April 4, 1986  
Fort St. Vrain  
Unit No. 1  
P-86266

SUBJECT: Appendix R Evaluation

APPENDIX R EVALUATION -  
FORT ST. VRAIN  
NUCLEAR GENERATING STATION

REPORT NO. 1  
SHUTDOWN MODEL

FIGURE 2.1-5  
SHUTDOWN MODEL - NON-CONGESTED CABLE AREAS  
FORCED CIRCULATION COOLDOWN  
RCS COOLANT INVENTORY

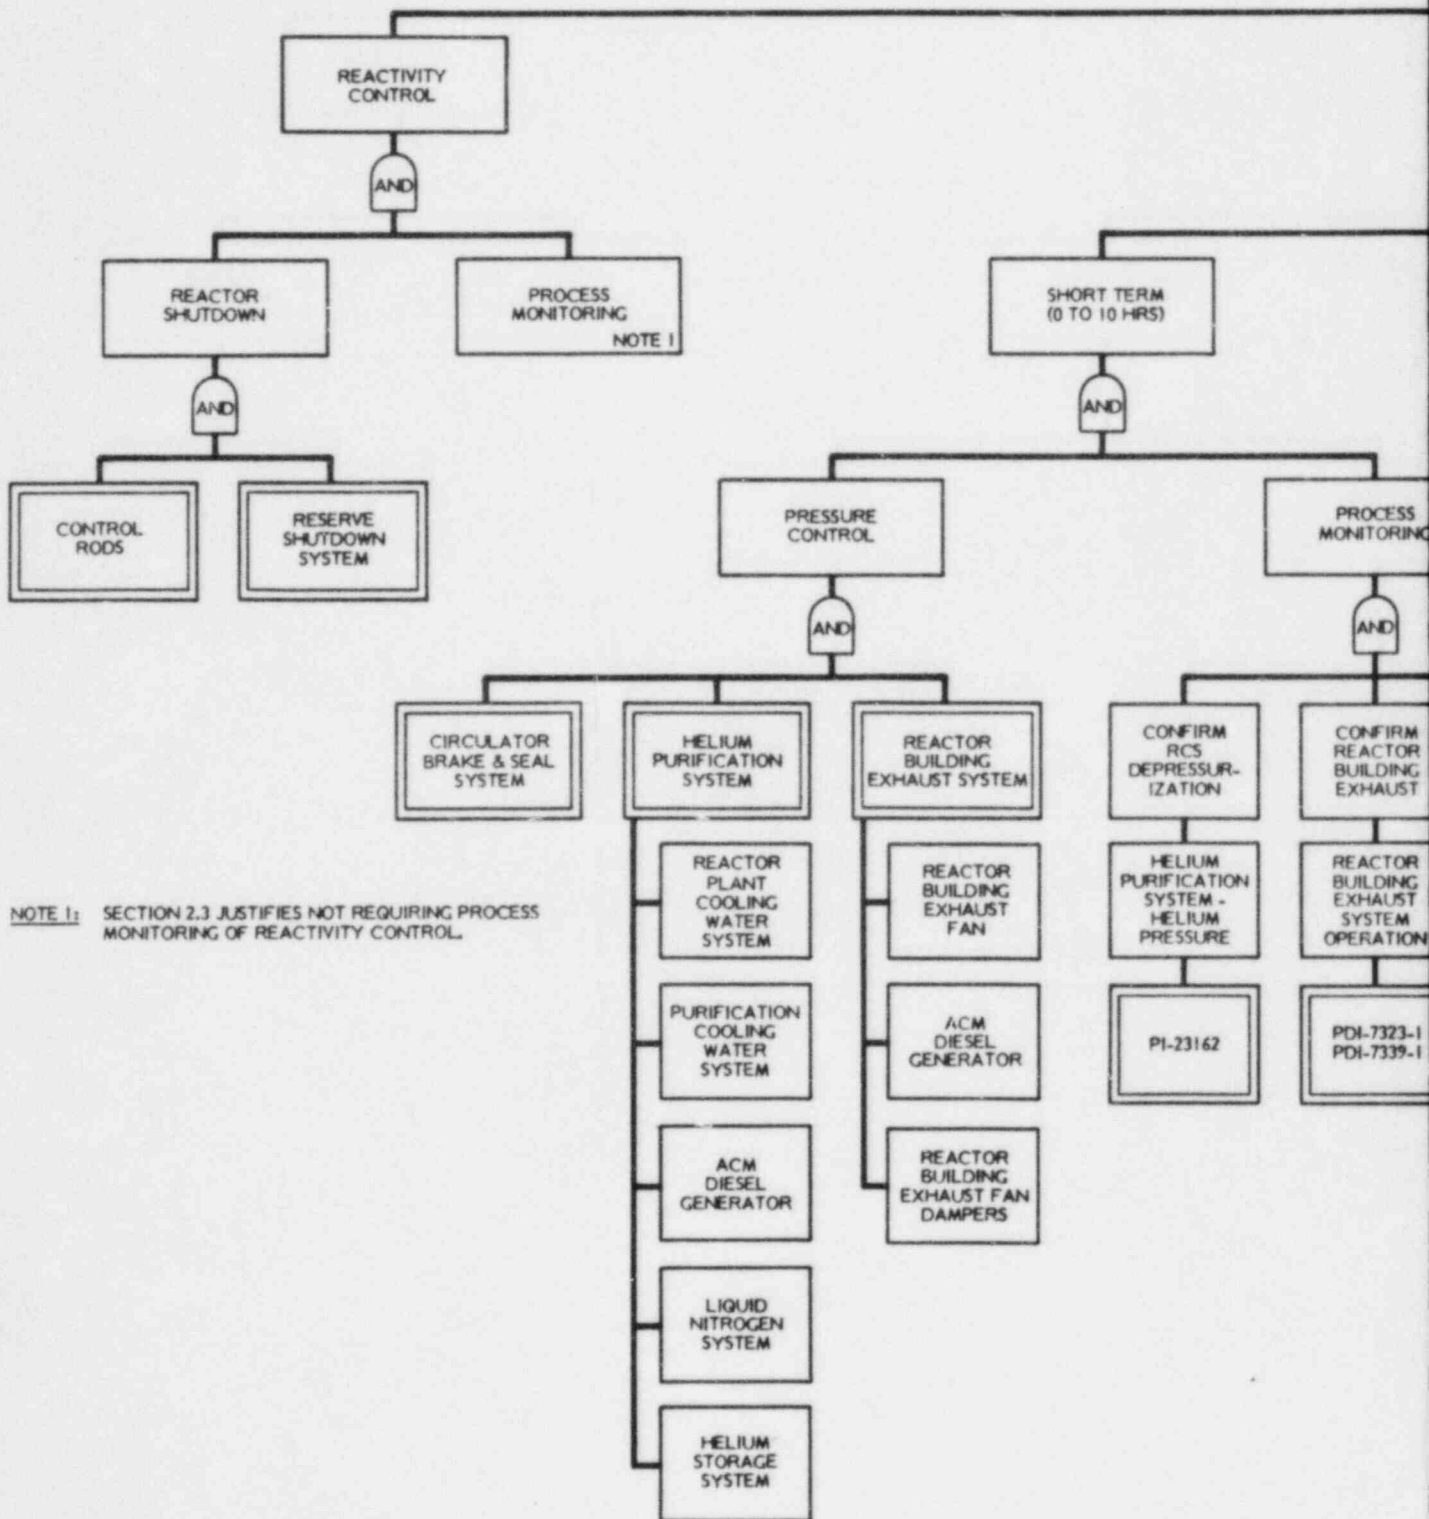
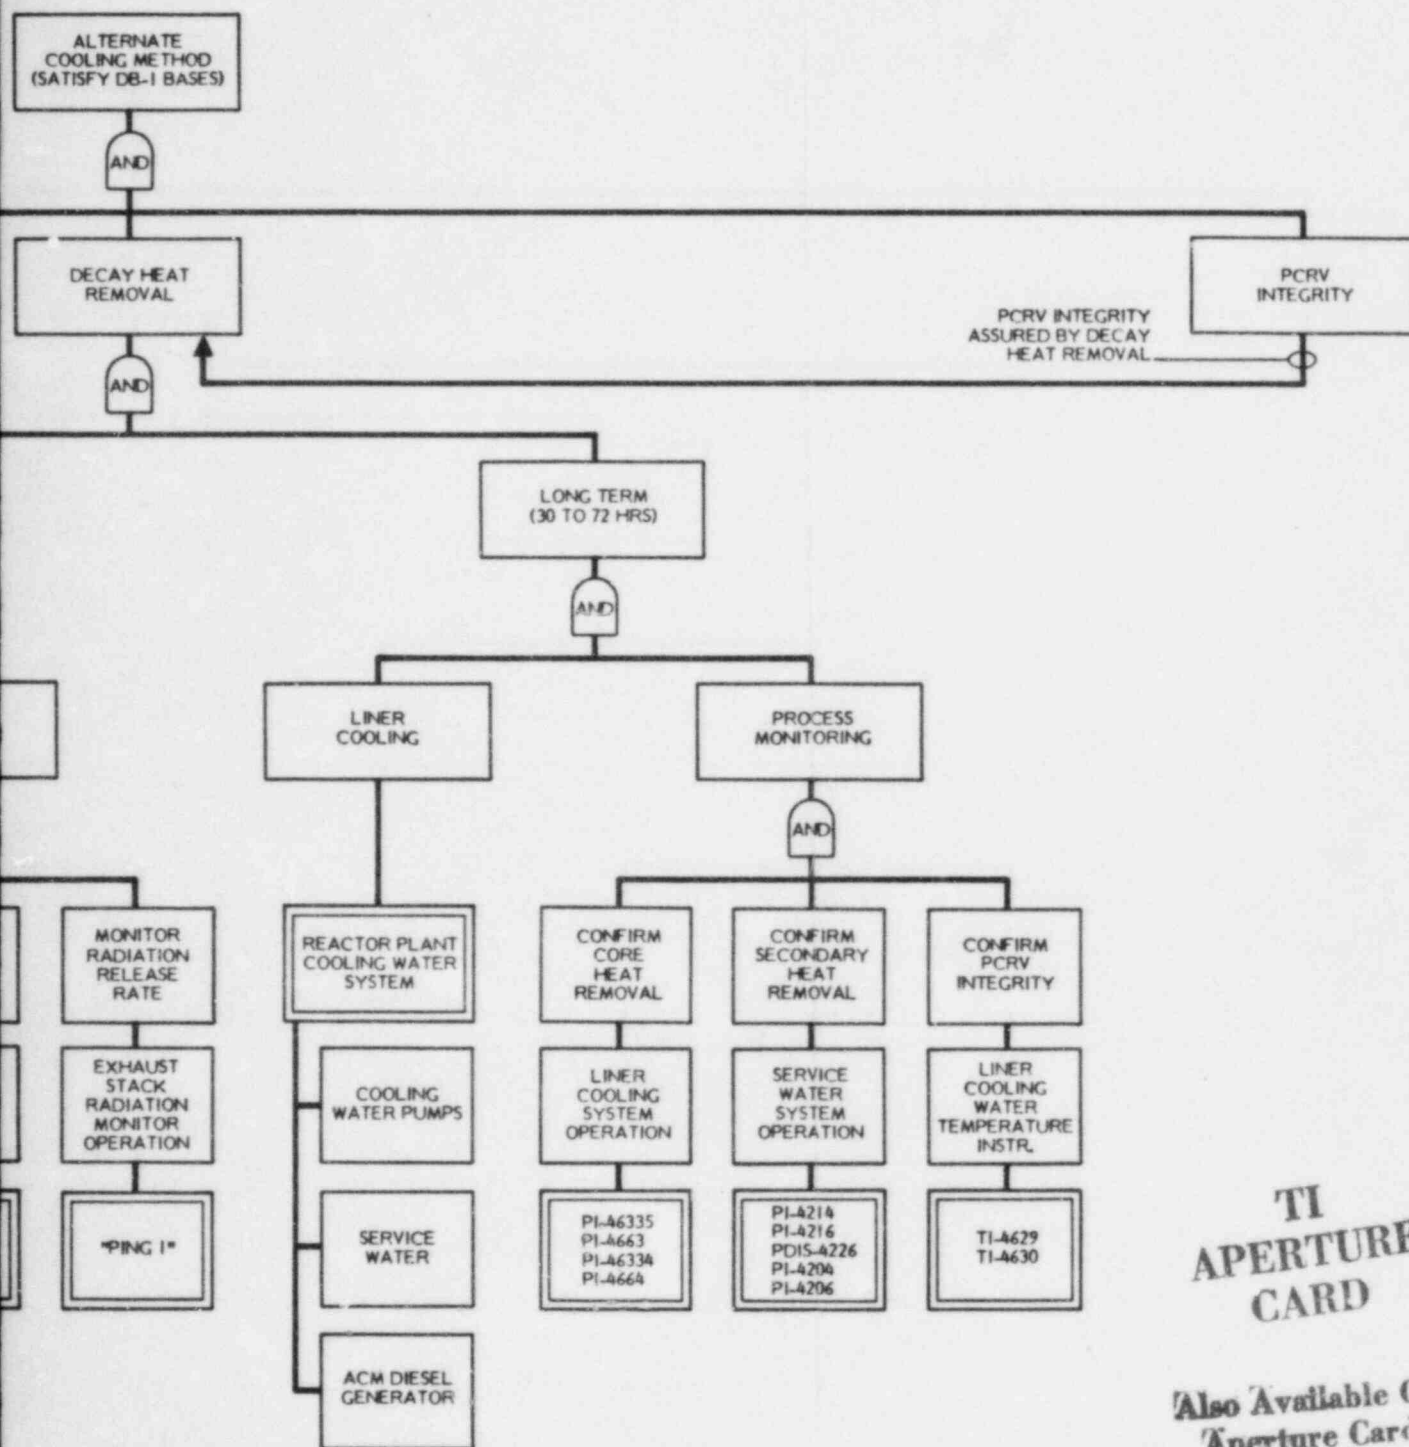
As committed to in the above referenced letter, PSC now submits the:  
1) justification of the valve position and alignment based on input from plant operations representatives (see attachment "A") 2) the page changes to Reports 1 and 3 to incorporate the manual pressurization system for the Helium Circulator Brake and Seal System into the shutdown model (20 copies of page changes included as attachment "B". Please incorporate these pages into the previously transmitted reports.) The commitment to provide the "manual actions and timing" details will be delayed until the early part of May. This is required because PSC is in the midst of labor negotiations which may affect the manpower available on back shifts.
